# UNITED STATES PATENT AND TRADEMARK OFFICE

APPLICATION NO.	FILING DATE	FIRST NAMED INVENTOR	ATTORNEY DOCKET NO.	CONFIRMATION NO.
09/803,412	03/09/2001	Harry W. Schmidt	T268.12-0047	4806
26285	7590	03/17/2005		
KIRKPATRICK & LOCKHART NICHOLSON GRAHAM LLP 535 SMITHFIELD STREET PITTSBURGH, PA 15222				
			EXAMINER	
			CROSS, LATOYA I	
			ART UNIT	PAPER NUMBER
			1743

<b>Office Action Summary</b>	Application No. 09/803,412	Applicant(s) SCHMIDT ET AL.	
	Examiner LaToya I. Cross	Art Unit 1743

Figure 3 (partial) of instant invention

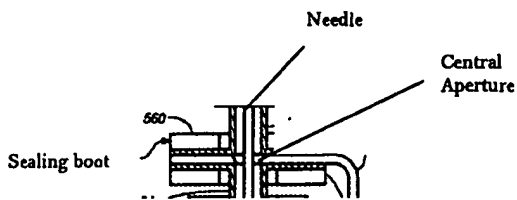
It appears that Applicants rely on their sealing boot (558) in combination with needle block (574) to support their claim of a "seal". However, the needle block feature is not a part of the instant claims. The Examiner understands Applicants' argument that according to the disclosure of Stone and figure 4 of Stone, the vial stabilizer (320) never reaches needle housing (280). However, the needle housing of Stone would be equivalent to the needle block of the instant invention, which is not claimed.

Furthermore, according to the specification, Applicants' sealing boot is depicted by reference character (558), which is shown as a structure disposed about the sampling needle and having a central aperture through which the needle may move. Stone shows the same structure surrounding the sampling needle and having a central aperture through which the needle may

Figure 3 (partial) of Stone

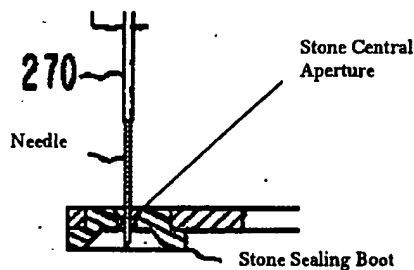
Applicants point to the teaching in Stone that the vial stabilizer has a central aperture allowing it to move freely with respect to the inner and outer needles and assert that this teaching prevents any seal from forming between the vial stabilizer and a vial. It is unclear, however, how Applicants can draw such a conclusion from this teaching. In comparing the instant invention to that taught by Stone, both devices have the structures and operate in the same manner. In the instant invention, there exists an aperture in the sealing boot that will allow the needle (556) to move freely through the sealing boot. Compare figure 2 of instant application, where sealing boot is located at the bottom of the needle to figure 3 of the instant application, where the needle protrude through the sealing boot into the vial. See also, figure 3 of Stone where the vial stabilizer is located at the bottom of the needle and figure 4, where the needle protrudes through the sealing boot and into the vial. Figure 4 of Stone clearly shows that the vial is completely engaged with the vial stabilizer.

move. Thus, although Stone may not disclose the vial stabilizer as a "sealing boot", the structures are the same.
